TECHNICAL SERVICE BULLETIN 84-1285 REMEDY INSTRUCTIONS

Make(s): Champion Bus Model(s): Challenger, Crusader, Impulse & LF Transport on E-450 chassis Model Year(s): 2021	Repair Code: SB-386-22-00-003974 Allotted Time: 0.5 hrs. Inspection Code: N/A Allotted Time: N/A
	Concern: InPower Fast Idle does not function properly due to the OEM tie-in harness is either incorrectly pinned, has a lack of +12V power supply, or both.	Photo(s) Required: No Prior Authorization Required: No Part(s) Number: N/A Part(s) Return: N/A

CORRECT LOCATION

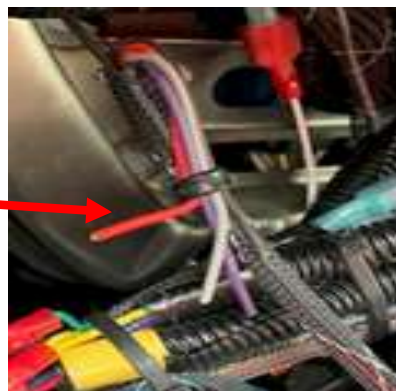
2. Locate the green wire on the 12-position harness connector that runs through the firewall.

3. If the green wire is seated at Pin #10 instead of Pin #11, this may be the reason for an inoperable Fast Idle. Separate the connector and use a de-pinner tool to remove the green wire from Pin #10. Move the green wire over to the next position, Pin #11.

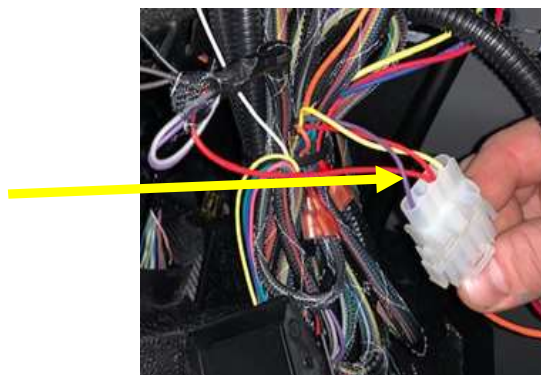
1. The InPower Fast Idle Module is located underneath the steering column. Locate the module and check for power. If you do not see any lights on the module, then it is missing a +12V ignition power source.

2. The Red wire from the InPower Idle harness must see +12V ignition power. The Red wire will be located with the zip-tie along with the Purple and Gray wires. If the Red wire is not connected to anything, this may be the reason no lights are showing on the module.

3. Connect the Red wire to the 4-position lift connector located in the same area. Place the Red wire in Pin #2 of the connector. It may be necessary for the Red wire to share the same terminal with an existing red wire from the Wheelchair Lift Interlock Module. You should now see lights on the InPower Fast Idle Module.
